Our Ref: 14683-HISC-EJE RtS2 (rev.1)
Date: 9 March 2026

RE: **Response to Submissions 2 (RtS2) – Hunter Indoor Sports Centre (SSD-65595459)**

This architectural statement supports the Response to Submissions 2 (RtS2) for State Significant Development Application (SSD- 65595459) for the proposed Hunter Indoor Sport Centre (HISC) at 2 Monash Road and 24 Wallarah Road, New Lambton.

Figure 3 – Site Entry & Exit Bus Swept Paths - Turton Rd

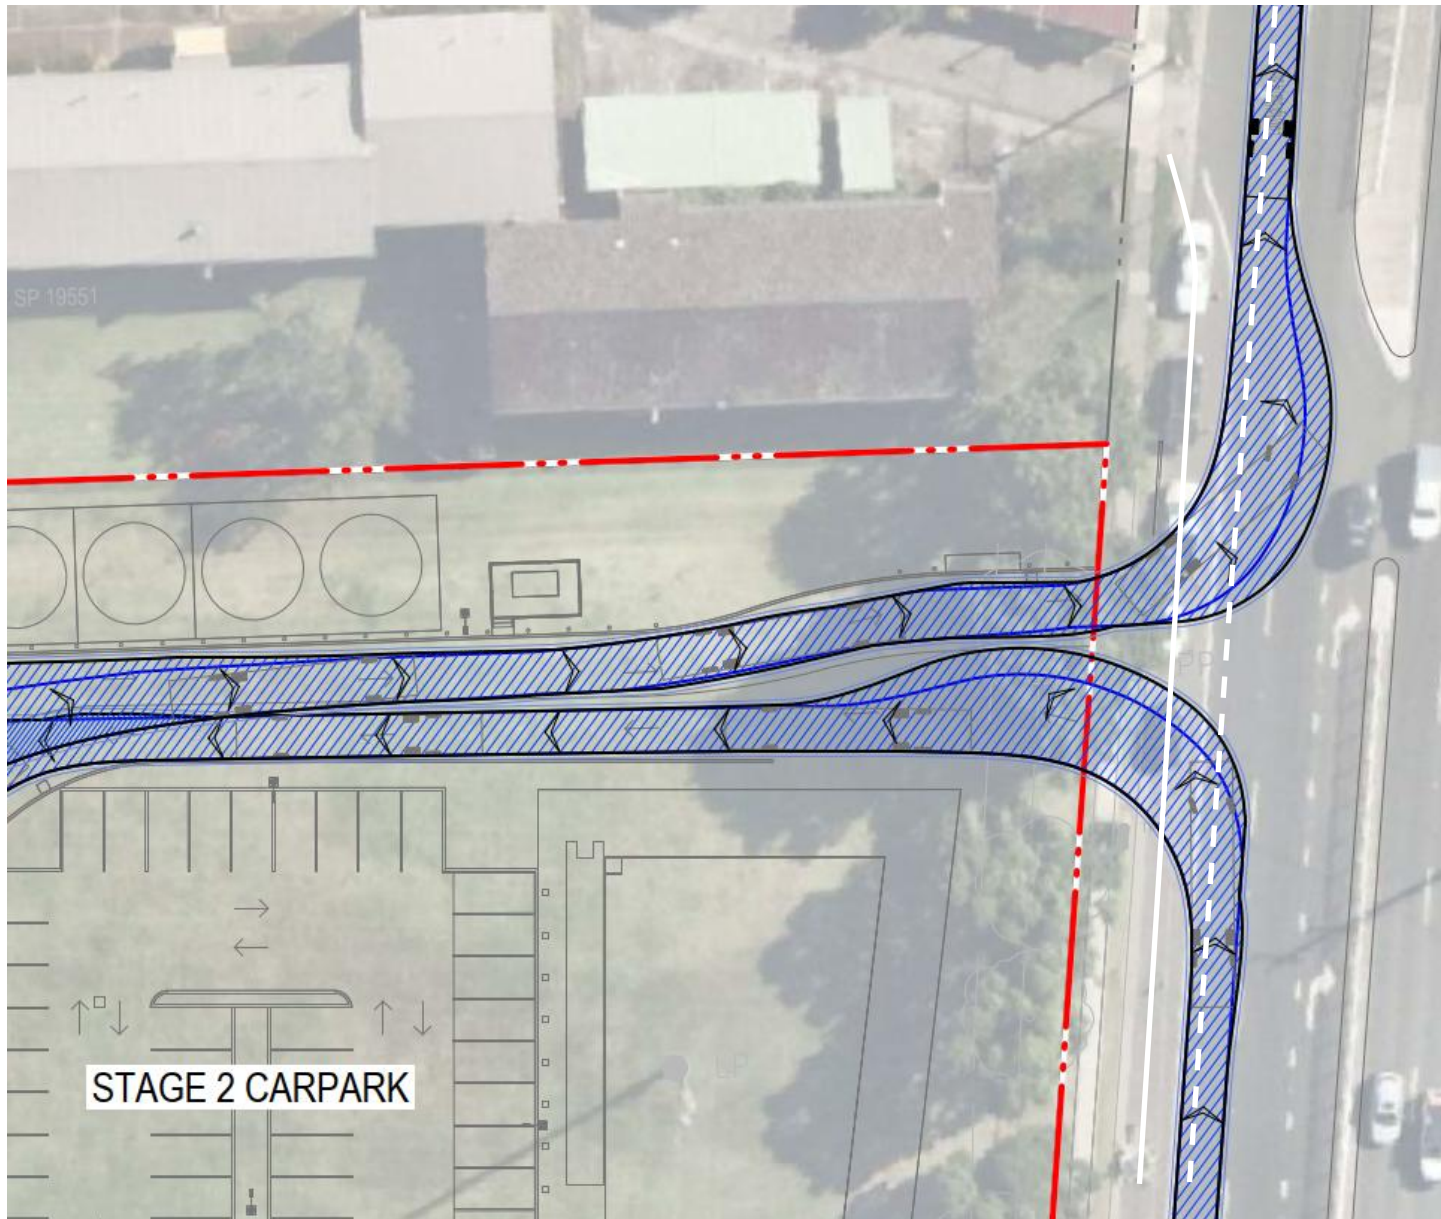
The swept paths for a 14.5m bus require traversing multiple lanes on Turton Road when entering and exiting the site. What is the impact on traffic queuing and safety both in the car park and on Turton Road?

It is also noted such buses result in potential vehicle conflict within the car park itself. It is recommended the layout be revised to address this concern.

The swept paths shown by Groundswell (refer to drwg DA-980-01, & part screenshot/Fig.3 below), demonstrate that a 14.5m long rigid bus, turns entirely from the kerb side lane of the two north bound lanes, when entering the site. Given there is adequate parking provided within the site and adequate queuing distance prior to reaching the parking zone, it is not considered there will be any safety issues within the carpark or Turton Road.

When egressing from the site, the 14.5m long rigid bus utilises the pavement within Turton Road (i.e. both travel lanes). It is unclear why the bus would need to demonstrate turning into the kerb side lane of the two lanes only, as this would be an unsafe and illegal manoeuvre if there was a vehicle travelling north in the second lane. If the driveway was further widened to allow buses to turn into the kerb side lane only, then this would result in a poor outcome for pedestrians in the footpath, as it would increase the width of the driveway beyond the guidelines for pedestrian crossings.

Figure 5 – Additional Bicycle Parking Spaces

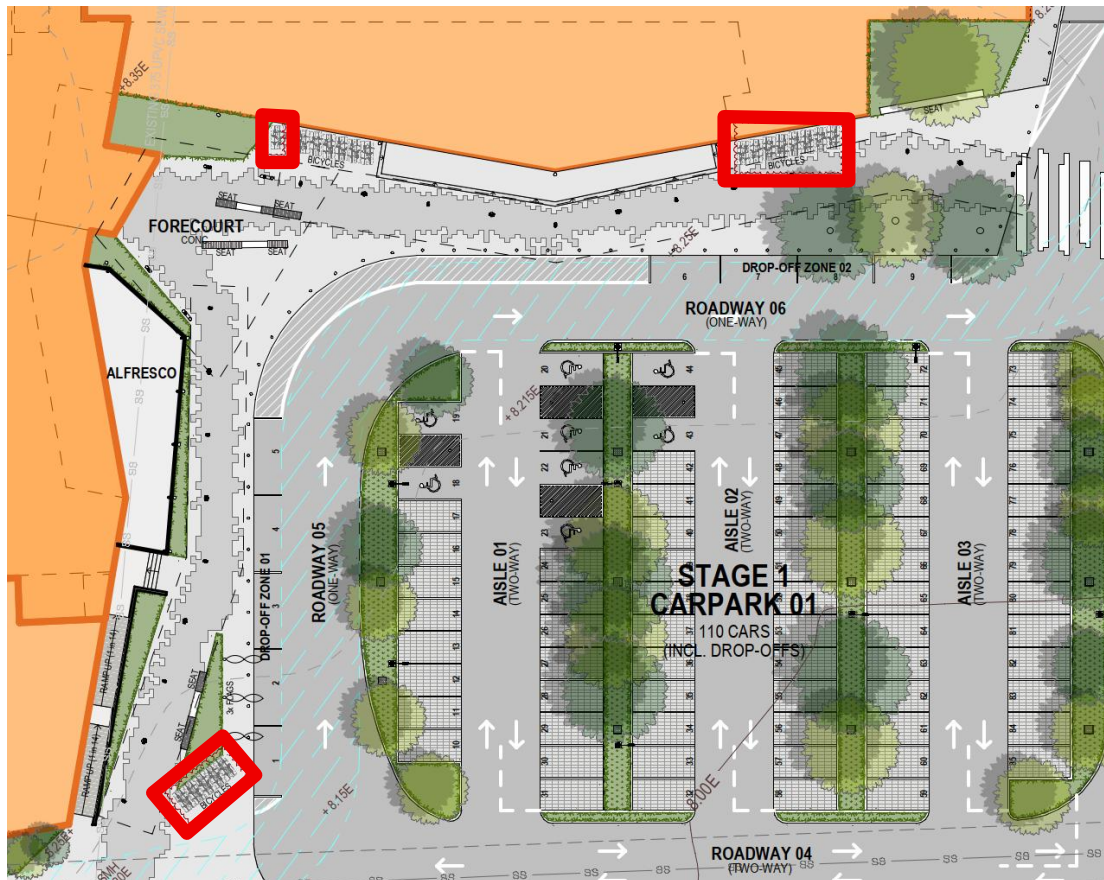
Bicycle parking is to be increased to better align with the proposed patron numbers and minimise reliance on vehicles.

An additional 28x secure visitor bicycle parking spaces have been added externally in the carpark, as clouded in red on the Proposed Site Plan (EJE drwg A43), to respond to CoN's request of providing a total of 50x spaces on site (incl. the 22x spaces previous proposed). See part screenshot / Fig.5 below where marked-up in red.

Figure 13 – Main Entrance Promenade Tree Canopies

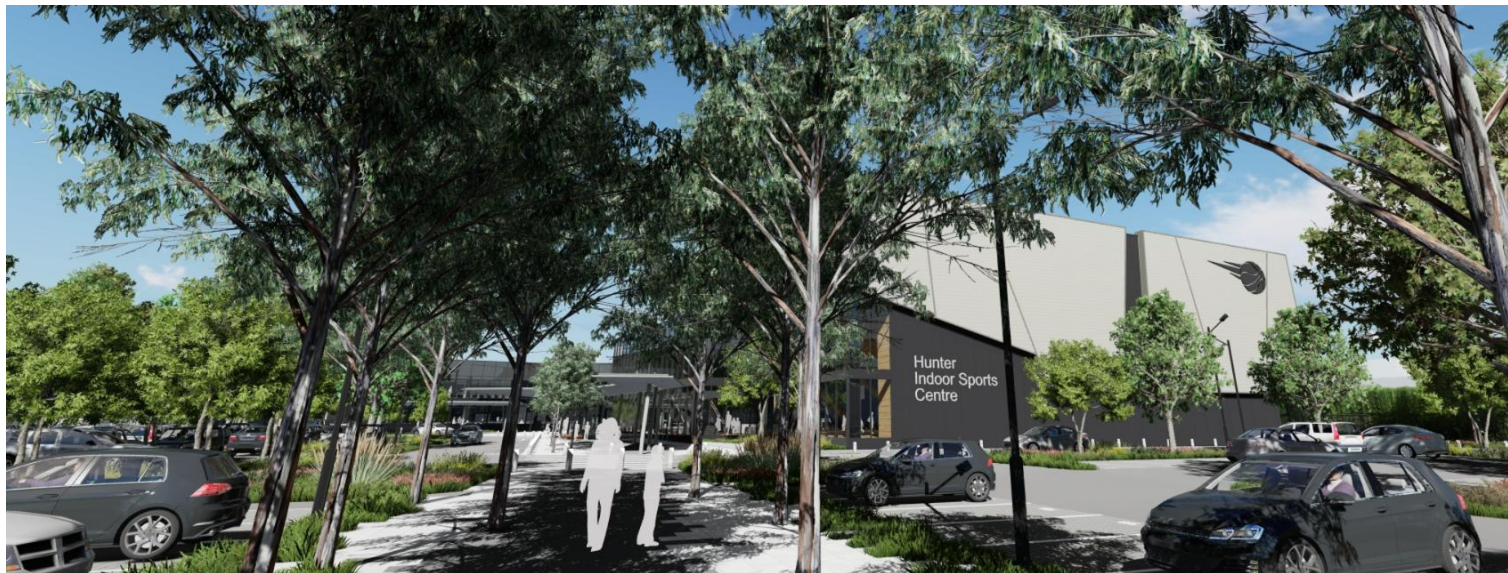
Provide heat protection for people moving from the car park into the building.

Shade canopy trees and an overhead canopy roof along the forecourt provide shade whilst additional seating and rest areas have been incorporated within the landscape design. See Fig.13 below of the tree canopies over the main entrance Promenade.

Figure 15 - Typical Carpark Rain-Garden

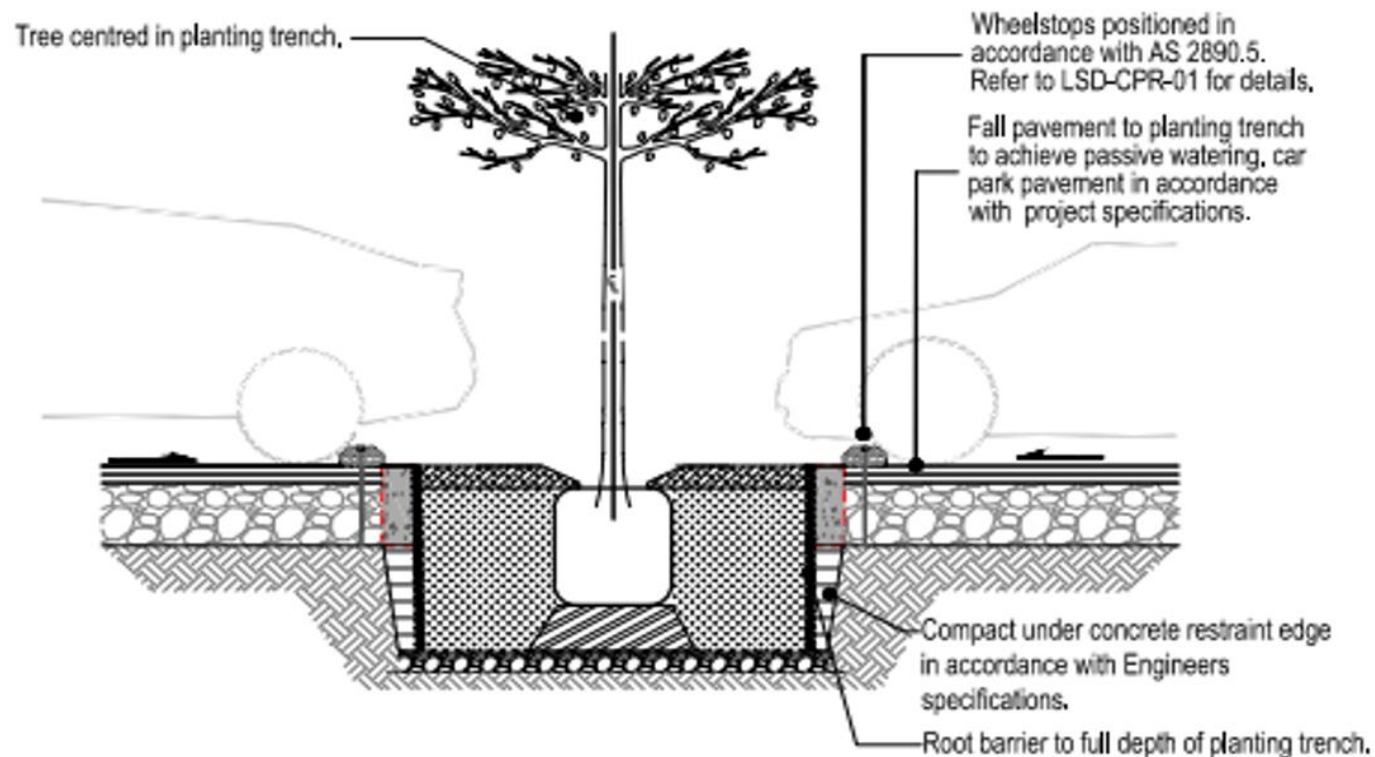
Reduce and rationalise the quantum of vehicle circulation space.

Typical car parking bay depths have been reduced from 5.4m to 4.8m (as original proposed, & as allowed under AS2890.1-2004), to allow the front ends of the spaces to overhang landscaped rain-gardens (with wheel-stops provided), to maximise landscaping & to reduce hardstand pavements within the carpark. See Fig.15 below of a typical carpark rain-garden sectional detail between opposing car parking bays.

Figure 22 – Monash Rd Entry Approach

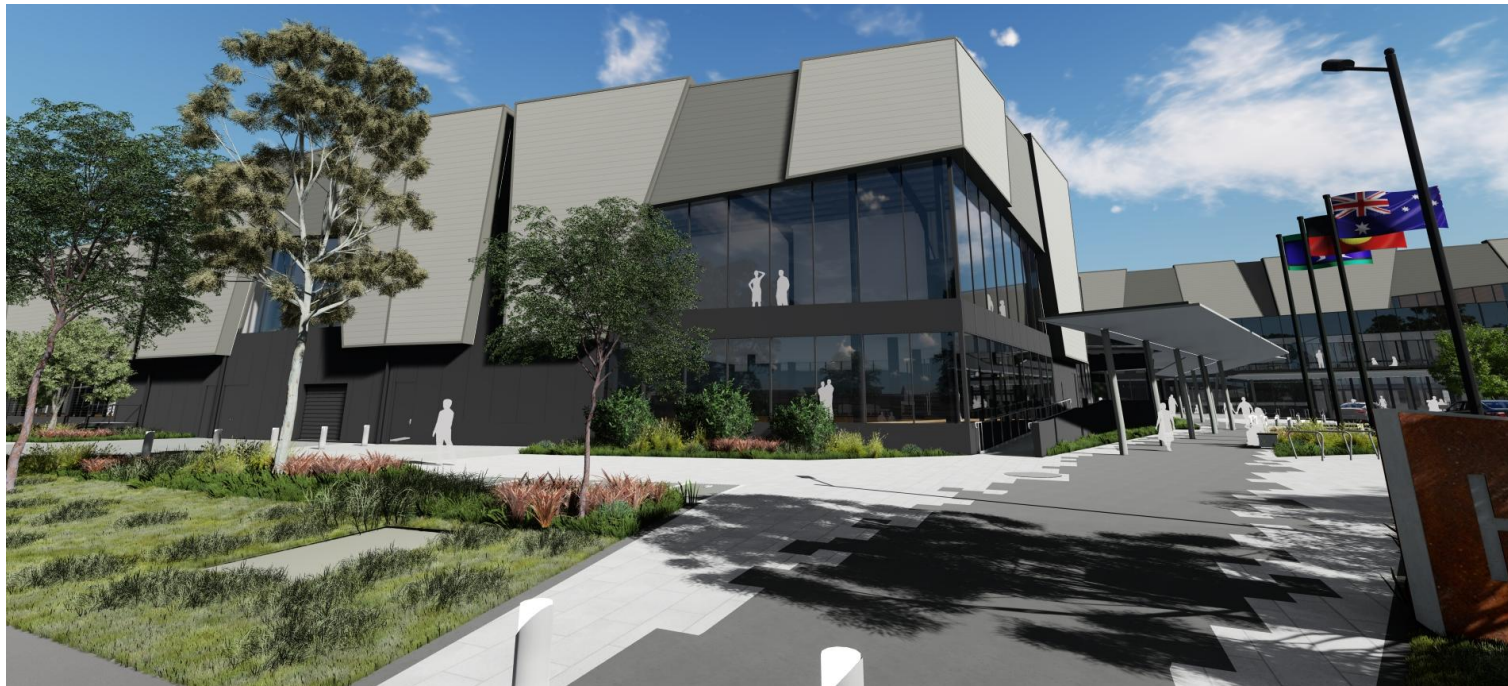
Clear and safe pedestrian entry point/s across from Monash Road.

The existing pedestrian link to Monash Road has been enhanced and prioritized through redesign of pavement surfaces and relocation and screening of service zones. The corner of this built element also addresses and enhances the corner. See Fig.22 below.

See Figs.33-36 below of different court / sport modes from EJE drwgs A1005-A1008.

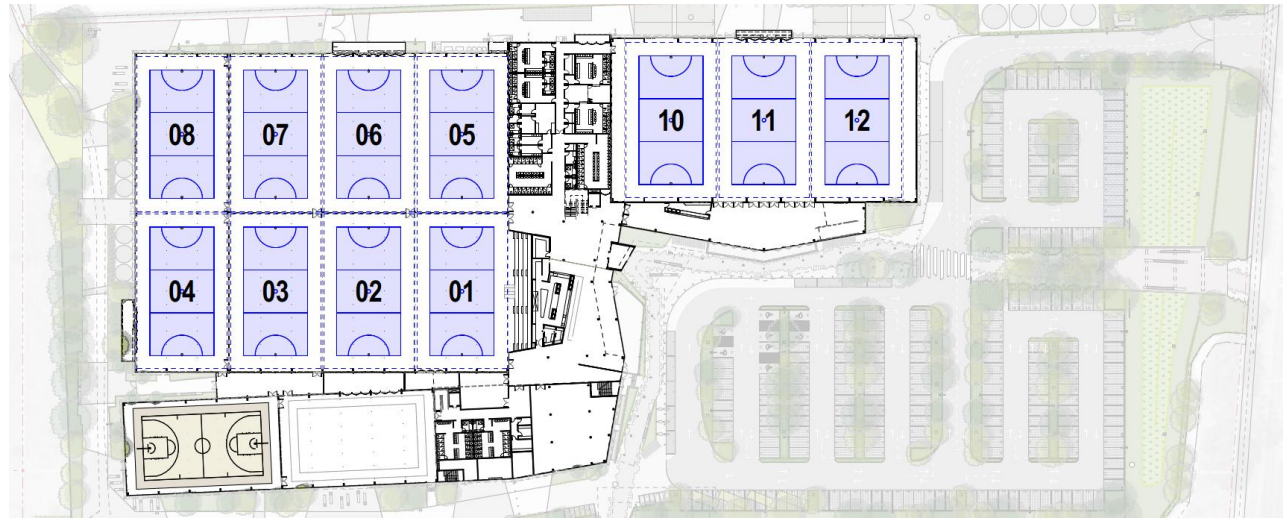
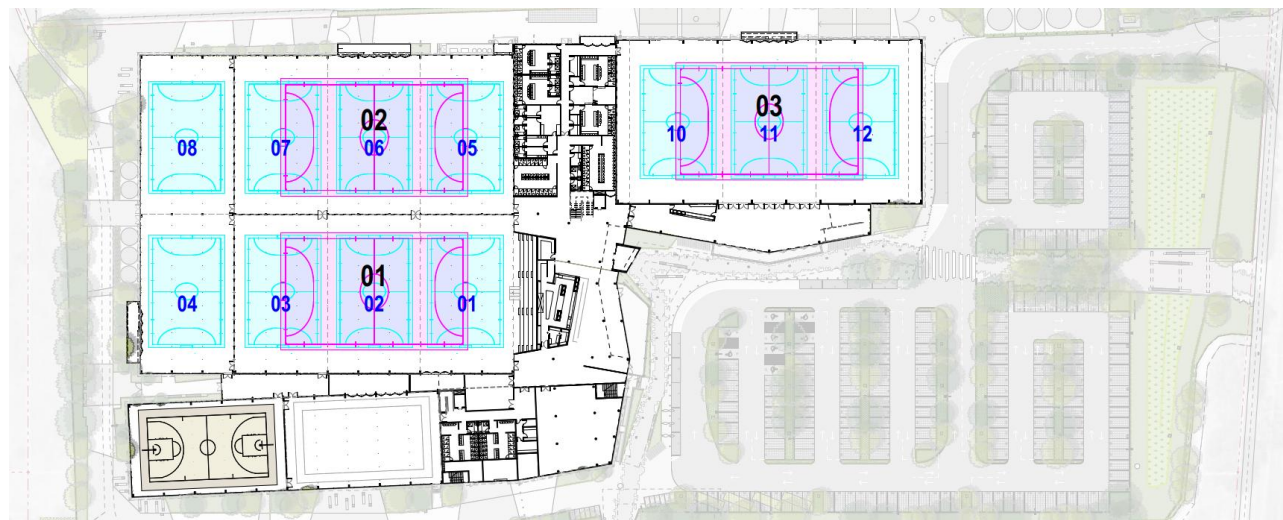
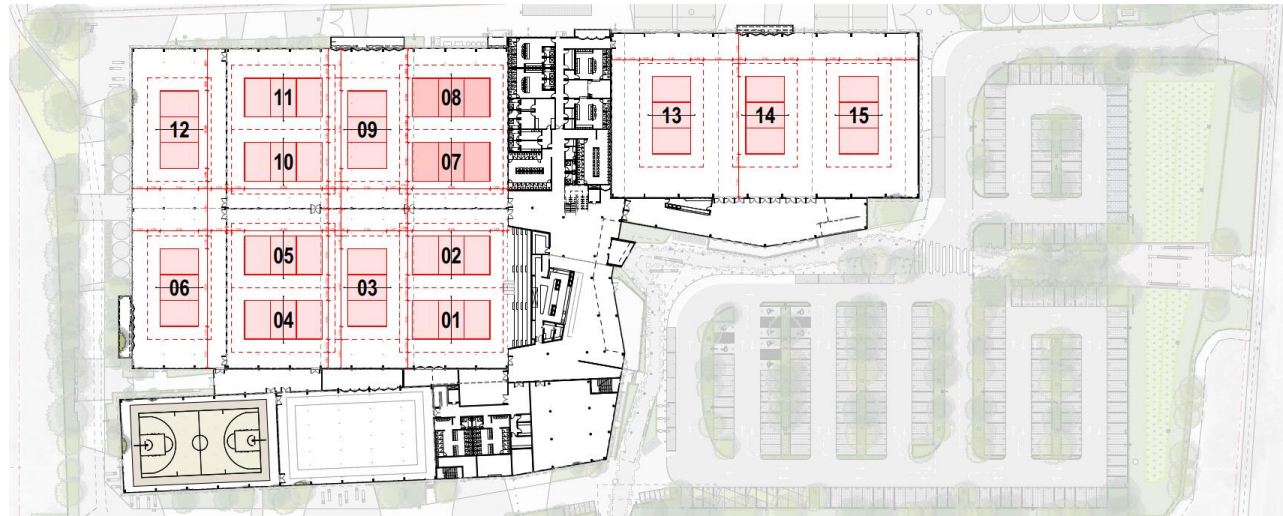
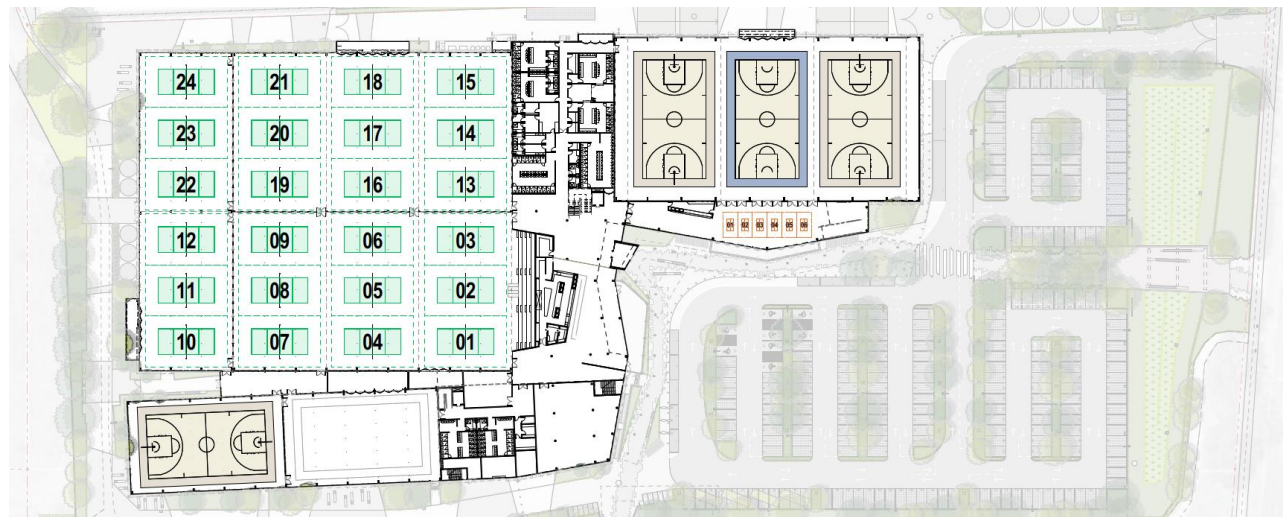
Reconsider the internal planning, hierarchy and functional layout and explore an efficient use of space for diverse user groups to better engage with the local school and wider community

Figure 37 – Back-Court Dividing Walls (marked-up in red)

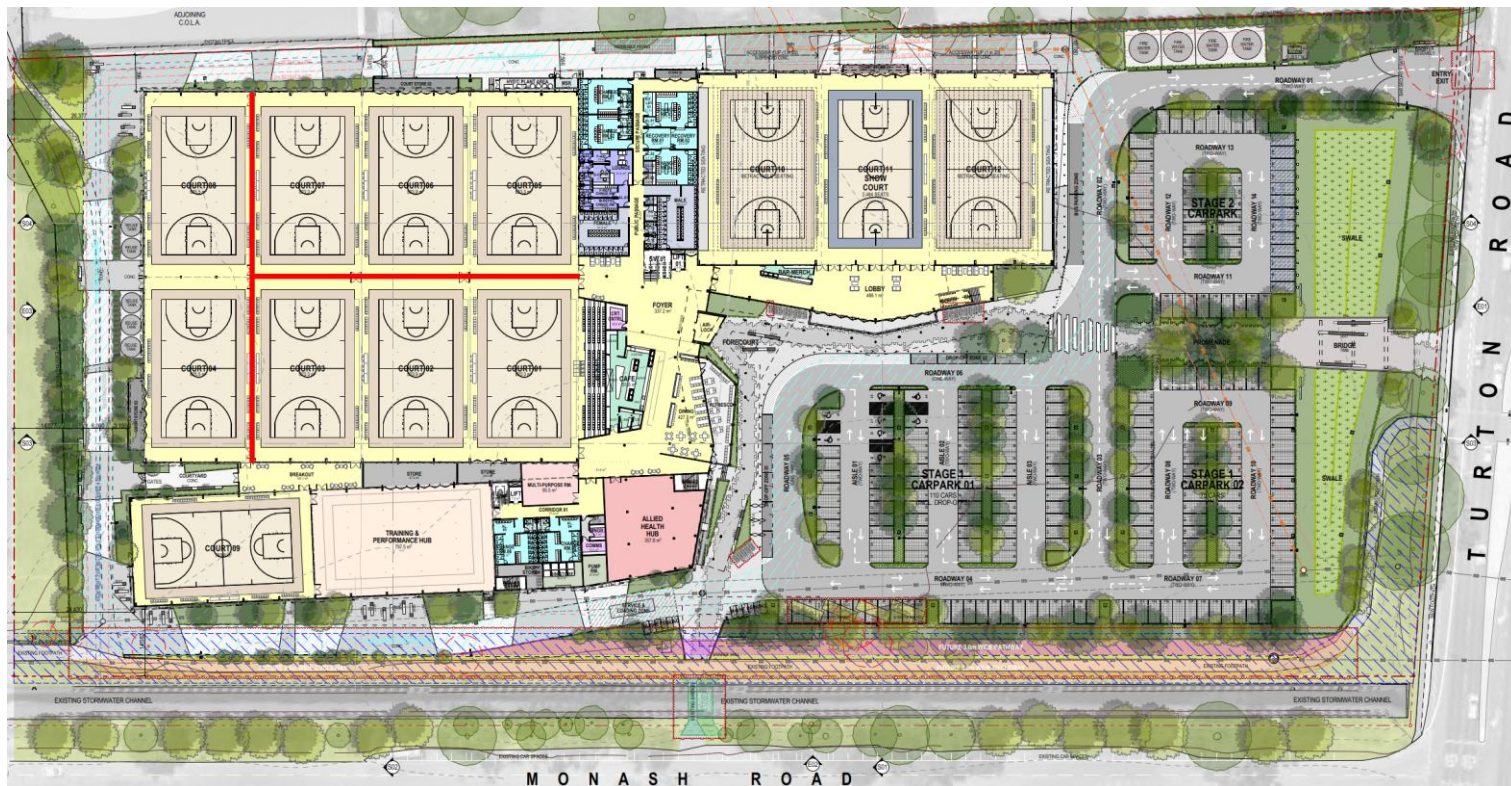
Test the acoustic impact of the arrangement of eight open courts and consider opportunities for the arrangement to be interspersed with amenities which may provide noise mitigation.

The eight internal courts are to be broken into three halls with acoustic glazing providing visual connection between spaces whilst reducing the overall acoustic impact of multiple courts being used at one time.

Figure 42 – Permeable Paving Extents (shaded yellow)

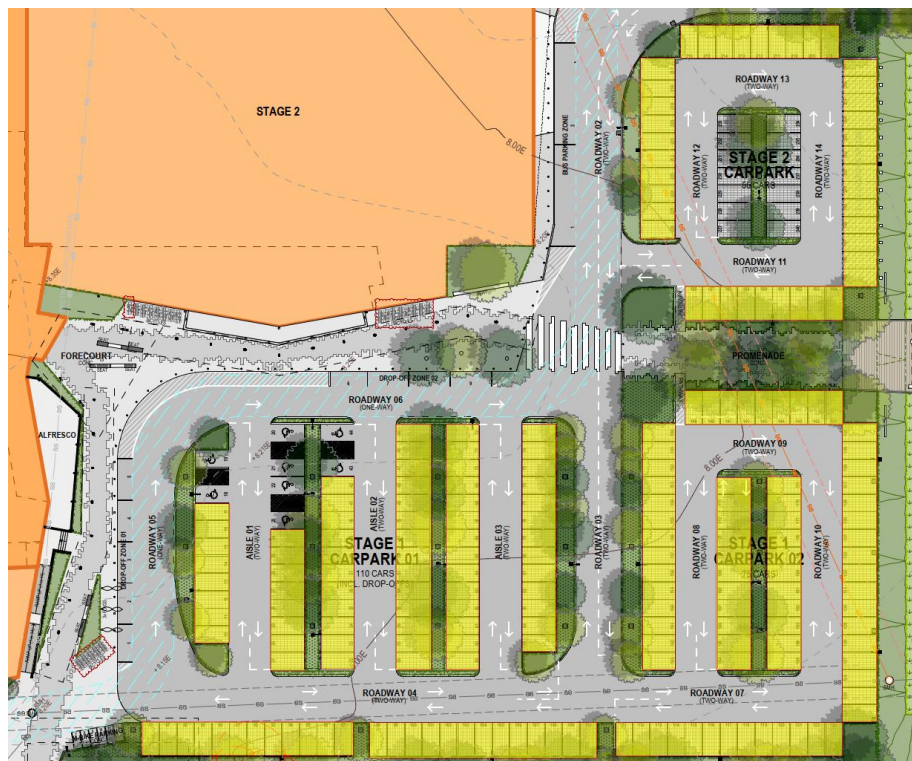
Explore opportunities for a further reduction of hardstand areas and expansion of permeable surfaces such as permeable paving to better align with WSUD principles and flood resilience. Department of Planning, Housing and Infrastructure point 5d

All car parking spaces in the carpark (except accessible spaces), have been amended to be of a permeable paving surface finish, to respond to the SDRP's comments, as shown on the Proposed Site Plan (EJE drwg A43). See part screenshot/Fig.42 below, where shaded in yellow.

It should also be noted, that the car spaces are designed at 4.8m deep, with the remaining 0.6m min. required length (for a min. total length of 5.4m under AS2890.1), occupied by garden beds, to already minimise hardstand areas, & to maximise landscape areas & rain-garden opportunities, as part of the overall WSUD strategy.
